**Objection by the Bloomsbury Association to the Discharge of Conditions
application (ref: 2019/0226/P): 112A Great Russell Street, London**

Application for a Discharge of Conditions (ref: 2019/0226/P)

8 February 2019

Plan GRS-1103 (revP1)

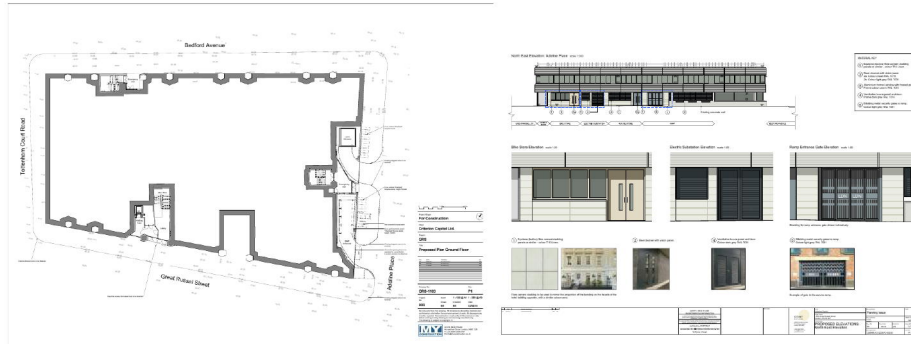
- No manufacturer's specification or details of facing materials including colour and samples of those materials are provided, as required by the condition.
- No plan, elevation and section drawings, including fascia, cornice, pilasters and glazing panels of the new hotel entrance are provided at a scale of 1:10, as required by the condition.
- No details including sections at 1:10 of all windows (including jambs, head and cill details), ventilation grills and external doors are provided, as required by the condition.
- No details are given as to how ventilation grills will be specified and detailed in order to meet the acoustic requirements of Condition 9, which sets limits for noise from plant and equipment, all in the interests of protecting the living conditions of nearby residents. The Inspector's decision paragraphs 17, 23 and 24 refer.

- No details of service ducts are provided, as required by the condition. This requirement is linked to Condition 3 to which the Inspector refers in his decision (paragraph 42) and is also relevant here.

- 3.04 Of significant concern also is that drawing **GRS-1103(revP1)** submitted as part of the application shows a materially different proposal from the approved plan 2897/P/11/rev F:

- Lifts connecting the street to basement accommodation are omitted, and what could be a relocation of the main entrance to the underground hotel from Great Russell Street to another unspecified location. Good vertical circulation would seem an essential operational requirement for an hotel in a location such as this.

- What was originally proposed as the hotel entrance lobby off Great Russell Street is now only a fire escape stair, although the note 'main stair' might suggest that this could be a secondary entrance. The existing lift and lobby would not be adequate for hotel use and may be unsuitable for disabled access, non-compliant with Policy C6 of Camden's Local Plan.

- A relocation of the electricity substation on Adeline Place. This seems to be located where what was intended to be ventilation plant and ductwork.
- Ventilation plant and ductwork, fundamental to habitation of hotel accommodation below is omitted. It could not share the same space as the substation.

- The proposed fire-fighting lift has been omitted - again, an essential operational requirement.
- Service access to lower floors of hotel accommodation has been omitted.

- Vehicle crossovers have been retained to provide vehicle access with a different elevation to Adeline Place. The Inspector's decision relied on the removal of crossovers (paragraphs 30

- No off-street refuse storage area has been provided, as required by Condition 8.
- 3.05 Elevation drawing DMWR/A3/3233/PL-00300 (revP1) is resubmitted with the current application. It is exactly the same as the approved elevation and shows no more detail. The current plan, GRS-1103/P1, shows less information than the approved plan and is inconsistent with what is shown on the elevation. Drawing GRS-1103/P1 is also inconsistent with the same plan included in the Construction Management Plan.

Plan Drawing 2897/P/11F

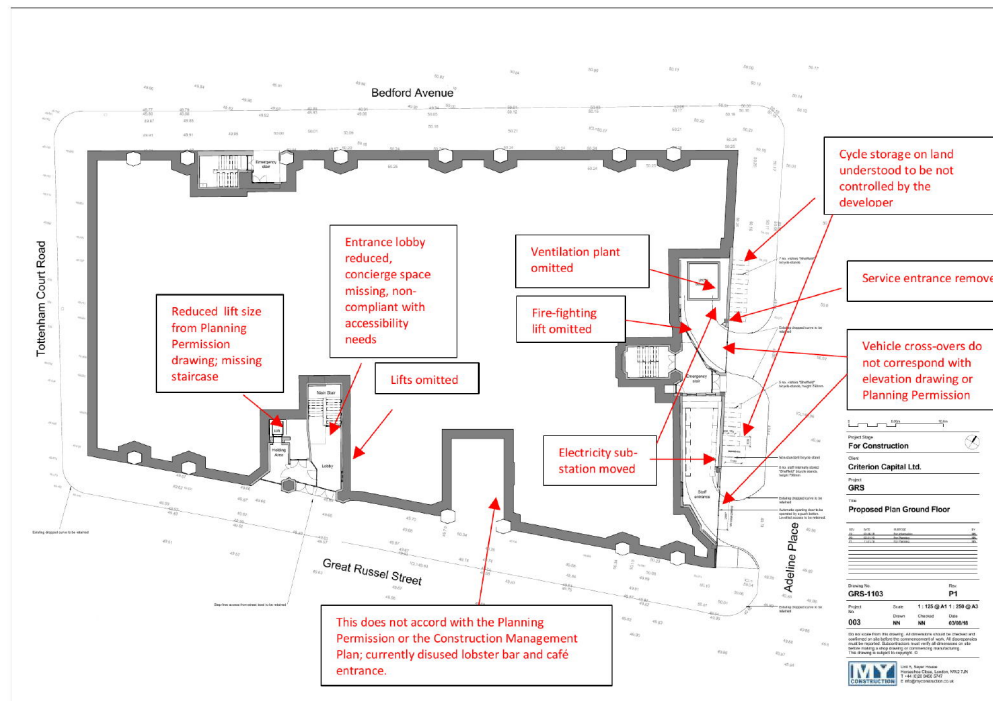
The latter shows no more detail than drawings 2897/P/11F and DMWR/A3/3233/PL-00300 (revP1) accompanying the proposal considered by the Inspector at Appeal [see below]. It is exactly the same as the approved elevation and shows no more detail.
